Memorandum No: 25-054

TO: Honorable Mayor and Members of the Fort Lauderdale City Commission
FROM: Rickelle Williams, City Manager *RW*
DATE: May 5, 2025
SUBJECT: New Police Headquarters — Phase 2 Peer Review

Fort Lauderdale Police Headquarters
WJE Peer Review, Phase 2 – Building Structural Design Peer Review

Figure 4. Detail 7 from Sheet HQ-S7-1-02 which shows CMU wall bearing on thickened slab-on-ground. Note that there is a vapor retarder under the slab-on-ground supporting the partition masonry walls

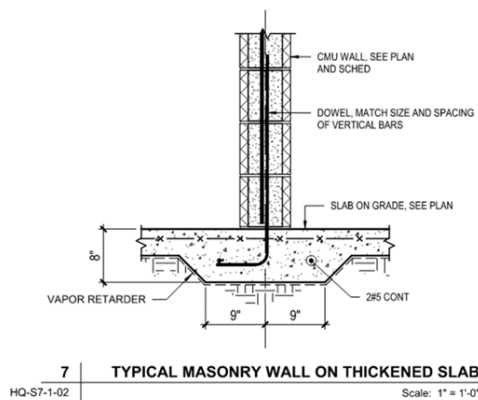
- On numerous sheets in the structural drawings (e.g., Sheet HQ-S2-2-1A), the CMU partition walls are referred to as "non-loadbearing CMU" which bear on thickened slab built over a vapor retarder (Detail 7 of Sheet HQ-S7-1-02). A vapor retarder would reduce the sliding resistance of the wall.

- **Masonry Wall Connection Details at Top and Bottom of Wall.** Both 7/HQ-S7-1-02 (Figure 4) and 2/HQ-S6-1-01 (Figure 5) indicate that the vertical reinforcement at the bottom of the CMU walls should be lapped with dowels. These dowels were to extend into the footing, or thickened slab, and be hooked. At the top of the CMU walls, two details are provided on Sheet HQ-S7-1-02, which is labeled as "Typical Masonry Details". Detail 3/HQ-S7-1-02 appears to be a detail for use with CMU walls that are bearing walls. A note in this detail also indicates that this detail applies when tie-beams are referenced on plan. We did not observe any tie beam references on plan, and we also did not observe on the plans where any CMU walls were explicitly designated as bearing walls. As such, Detail 3/HQ-S7-1-02 appears to not be applicable to the interior masonry walls. A wall schedule shown on HQ-S6-1-01 (see Figure 6) also does not explicitly designate any of the CMU walls as bearing walls. The masonry shaft noted above would necessarily be a bearing wall as it supports the end of concrete joists, but all other walls (not within Area E) appear to be non-loadbearing walls and in fact are believed to have been constructed as infill after the concrete structure was built. Detail 6/HQ-S7-1-02 (Figure 7) is further divided into two details, a typical detail that applies to both interior and exterior walls and an alternate option that applies to interior walls only. The typical detail shows the vertical reinforcement of the CMU wall embedded into the slab above. No minimum embedment depth is provided, but the details note that the slab thickness must be a minimum of 4 ¾ inches. Section 042200 of the specifications, "Concrete Masonry Units" Part 2.6.C addresses "Top of Wall Anchors." This specification section is shown in Figure 8. Interior non-load bearing partition walls in Seismic Design Category A, which applies to the FLPHQ, are shown to allow PTA series anchors by either Blok-Lok or by Hohmann & Barnard (H&B). A specification sheet for PTA 420 HS anchors by H&B is shown in Figure 9. A lateral load capacity for the anchor is not provided on this sheet nor is the type of fastener (e.g., screws) required to connect the anchor to the concrete structure above. It may be that this information exists somewhere else on H&B's website, but we could not find it. As such, it is unclear to us if these anchors are approved or rated for lateral load transfer, and if so, what load they are rated for. Also unclear is the capacity that the SEOR assumed for these anchors. A rendering of the PTA 420 HS anchor at the top of a CMU wall (also taken from H&B's website) is shown in Figure 10. Note that the anchor is shown with the length of the top plate oriented transverse to the length of the wall, suggesting that its rated capacity would be applicable to out-of-plane rather than in-plane loading.

Figure 5. Detail 2 from Sheet HQ-S6-1-03 which shows CMU wall foundation for wall footings that have WF# designation on the foundation plans. Note that the vapor retarder under the slab-on-ground does not pass under the wall footing

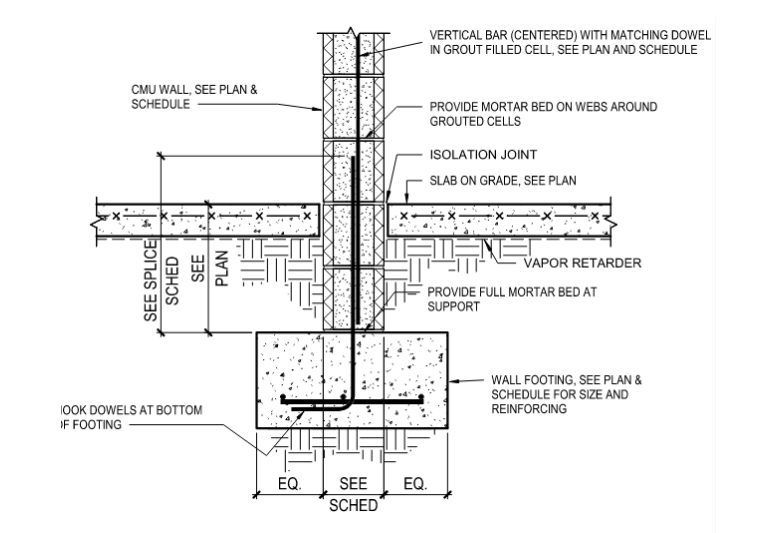
Furthermore, it is evident that the SEOR is aware of what good practices are for designing masonry shear walls, evidenced by the east-to-west spanning wall used in Area E. Unlike the partition masonry walls, that wall a) was constructed such that axial and diaphragm loads from the roof can be transferred to the wall (Figure 23), b) has vertical reinforcement that is well-anchored to develop shear-friction resistance (Figure 11), and c) has a standalone wall footing without a vapor retarder underneath it, thereby increasing the sliding resistance of the wall (Figure 5).

Figure 7. Detail 6 of Sheet HQ-S7-1-02 which shows two options for connecting the partition CMU walls to the elevated slabs or beams

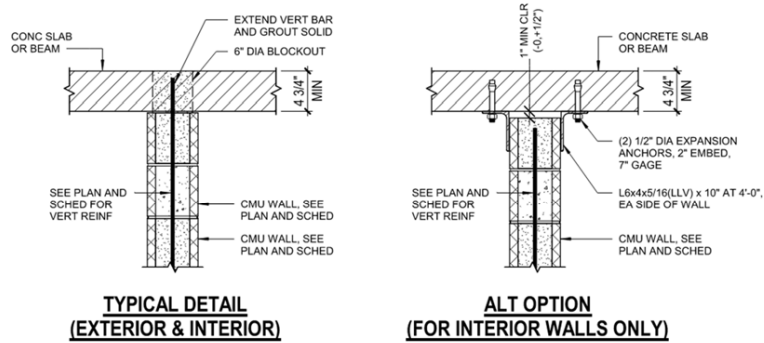
- None of the connections of the partition masonry walls (i.e., not including the bearing wall in the community room and the masonry core wall in the main structure) to the diaphragm shown in the structural drawings (Detail 6 of Sheet HQ-S7-1-02) or noted in the special inspection reports (i.e., PTA anchors) satisfy ACI 318-14 Section 12.5.3.7. In other words, these connections do not satisfy the shear-friction provisions of ACI 318, which invalidates the masonry walls as code-compliant contributors to lateral resistance.

- Furthermore, the alternate option provided in Detail 6 of Sheet HQ-S7-1-02 shows a minimum gap of 1 inch between the top of the walls and the bottom of the above floor. Should this detail have been used, the walls would only start resisting floor loading once (or if) the gap closed, clearly indicating that the SEOR did not originally intend for the walls to carry axial loading from the above floor. In their recent lateral system calculations package (dated almost three years after issuance of the permitted structural drawings), the SEOR indicated that axial load in the walls was requisite to develop the sliding resistance of the so-called "CMU shear walls." It is confounding that the SEOR would propose using a connection detail that effectively precludes axial load from entering the wall (apart from self-weight) if their design relied on sliding resistance, unless of course, the original design did not intend for those walls to be a part of the lateral system of the structure.

- **Diaphragm Shear Transfer.** The lateral load calculations package does not address whether the connections between the concrete floor diaphragm and masonry walls are adequate to transfer shear from the diaphragm. Detail 6 of Sheet HQ-S7-1-02 (Figure 7) of the structural drawings indicate two details for connecting the masonry walls to the slab or soffit beams. The first option (the “typical detail”) entails embedding the vertical wall reinforcement several inches into the diaphragm. Lateral load from the diaphragm might thereby be presumed to be transferred into the CMU walls through shear friction. However, Section 22.9.5.1 of ACI 318-14 requires that shear-friction reinforcement be developed on both sides of the friction interface, which the reinforcement in the wall is not, since per Section 25.4.2.1, the bars must be embedded at least 12 inches to develop the bar, which they are not. Therefore, this detail

does not comply with the ACI 318-14 code if its intent is to transfer diaphragm shear through shear friction. The second option shown in Detail 6 (the "alt. option") entails anchoring two angles into the diaphragm on either side of the wall, presumably to laterally brace it. Since the angles are not anchored into the wall in the detail, lateral load from the diaphragm cannot be transferred into the walls. Moreover, a gap with a minimum thickness of 1 inch is shown between the top of wall and bottom of diaphragm, the intent of which appears to have been to preclude the wall from receiving diaphragm shear and floor gravity loading until the gap closes. Additionally, various threshold inspection reports (e.g., No. 123) show PTA 420 HS anchors (produced by Hohmann & Barnard, Inc.) which are post-installed into the soffit beams and slabs using Tapcon screws and tied to the vertical reinforcement from the CMU walls (Figure 17, Figure 20, Figure 26, and Figure 27). This connection cannot reasonably transfer diaphragm shear into the walls either. Threshold inspection report No. 80 notes "CMU walls to be braced to the soffit beams using PTA 420 HS anchors as per approved summittal [sic] #0422000-13.0 instead of detail 6/HQ-S7-1-02," suggesting that these anchors were used for most connections of CMU walls to soffit beams. For these reasons, we recommend that the SEOR provide calculations for review demonstrating that the wall-to-diaphragm interface connections are adequate to transfer shear from the slabs into the walls.

Figure 17. Photographs from Threshold Inspection Report No. 081. Left photograph shows overall wall construction on first story at one location. Right photograph shows the PTA anchors at the top of the wall. Note that two screws are used to connect each anchor to the above element

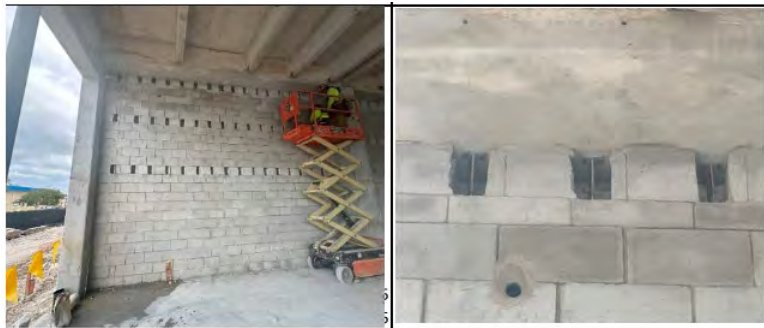
- **Report No. 081, Dated December 19, 2023:** Comments by the TI are in regard to the concrete used in slab-on-ground Pour 3. However, photographs of CMU walls in the first story are also shown in the report (Figure 17). These photographs show the overall CMU wall construction at one location in the first story and the approved PTA anchors at the top of the wall. The length of plate at the top of the PTA anchors is aligned parallel with the length of the CMU wall in contrast with the rendering shown on the manufacturer's website (Figure 10).

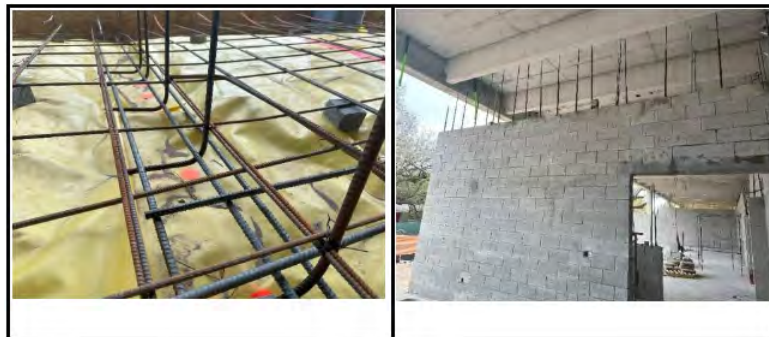
- **Report No. 107, Dated February 8, 2024:** The TI notes that “Partial inspection of slab rebar for SOG pour 5. Dowels for CMU need to be lowered to comply with what is specified on detail 7/HQ-S7-1-02.” Figure 24 shows a photograph of this condition and a photograph of a CMU wall under construction. Again, note that no shoring of the structure above is present, indicating that the CMU wall was not constructed as a bearing wall.

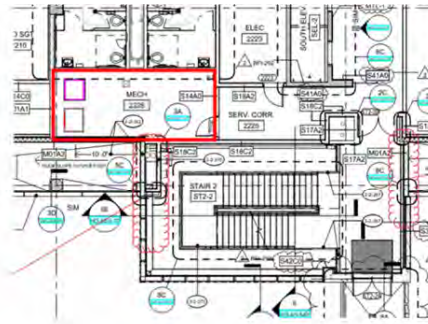
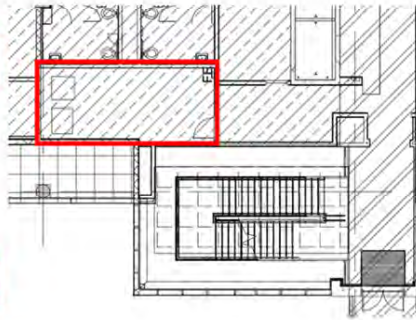
Most of the areas with mechanical equipment identified in the architectural drawings were accommodated in the structural drawings in the loading diagrams. However, we have identified one area on Level 2, south of Gridline 14, that was designated in the architectural drawings as a mechanical room but was not designated as such on Sheets HQ-S0-2-01 through 02 (Figure 30). It should be confirmed whether mechanical equipment will be installed in this area and if so, if it has been accounted for in the structural design. For our structural analysis (discussed later), we have assumed that the loading diagrams provided in the structural drawings are correct. Additionally, in some locations on the roof, both the weight of the mechanical equipment and the 150 psf allowance in live load are shown. We recommend that the SEOR confirms which load or combination of loads governed the design of the structure and specify so on the drawings. Currently, where equipment is installed, we do not know whether the equipment weight, or the specified 150 psf live load, or a combination of the two was used by the SEOR to design the structure supporting the equipment. Moreover, we recommend that the SEOR confirms if there is mechanical equipment in the area bounded by Gridlines H, J, 14, and 16 (or other areas which currently are not reflected in the structural drawings).

Figure 40. One potential location for the proposed new reinforced concrete shear wall

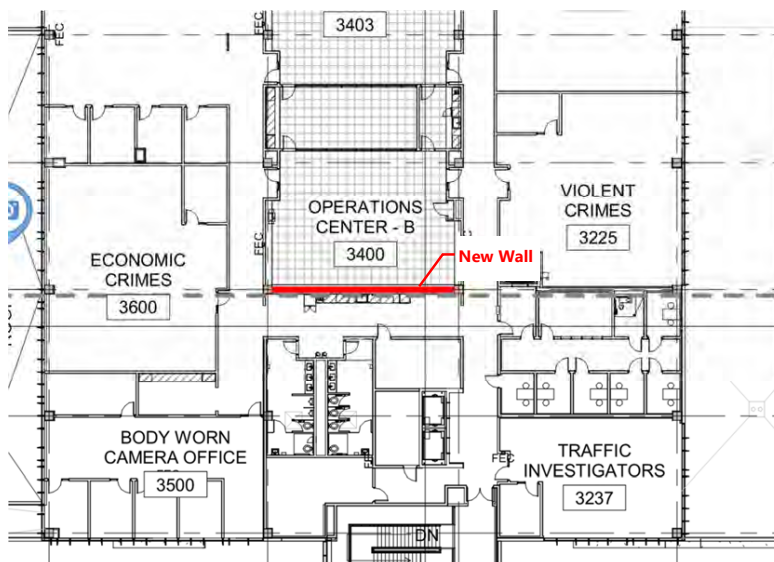
10. **Building Period.** Due to the relatively small length of shear wall in the southern half of the main building of the FLPHQ, the fundamental period of vibration of the building is over 0.9 seconds (which is significantly larger than typical concrete shear wall buildings having no more than three stories). The fundamental mode also corresponds with a twisting response of the structure. While this condition does not violate any code-prescribed performance limitations, it is not standard practice to design structures to perform this way. Adding an appropriately designed full-height shear wall (i.e., from foundation to roof) to the structure (as previously described) will rectify this condition.

The addition of a shear wall at the location recommended in Figure 40 will not fully rectify the sliding deficiency of mat footing CF-1 (under the north stair shaft). One way of enhancing the sliding resistance of this footing is to connect or tie it to adjacent column spread footings, as illustrated in Figure 41. If CF-1 is connected to the column spread footings at Grid Points J/3, K/3, and K/4, the additional gravity load on these columns will provide additional frictional resistance against sliding resistance for the combined foundations. To connect the footings, new segments of reinforced concrete foundations can be cast. These new tie footings sections should have sufficient strength to transfer the lateral sliding loads from the mat footing and column spread footings. The new tie footings would also need to be reinforced to preclude other limit states such as (e.g.,) one-way shear.
